Meeting Summary

Technical Team #11

January 24, 2018 | CDOT Offices – Golden

Mountain vs. Median Decisions and Alignment Review

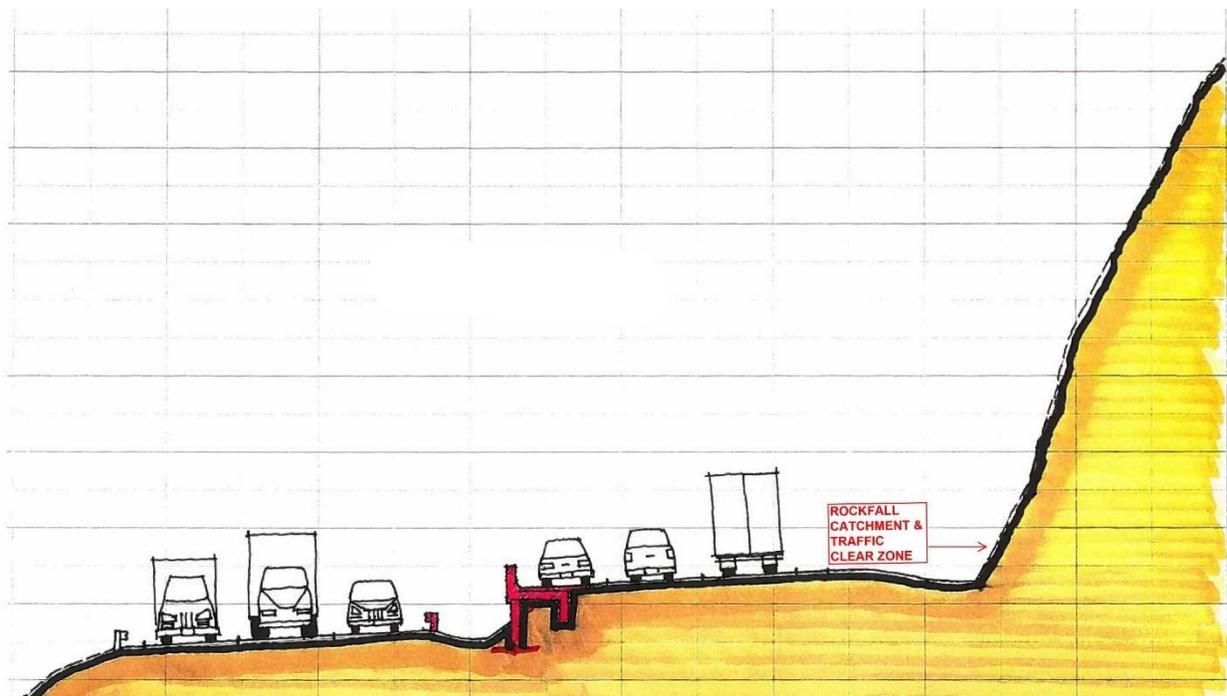
The above graphic depicts the alignment when the wide shoulder is moved from the right to the left hand side, bringing traffic closer to mountain. This can increase the risk to interact with rocks. It also decreases the clear zone, an area needed for recovery. Rockfall catchment needs to be considered as well. This option involves a considerable amount of blasting, scaling and removals.

The above graphic depicts an option where the road moves toward the median and the right hand (shoulder) white line stays where it is. This prevents all lanes from getting closer to the rockfall areas. This would involve a retaining wall up to 5 feet tall near the center of the median.
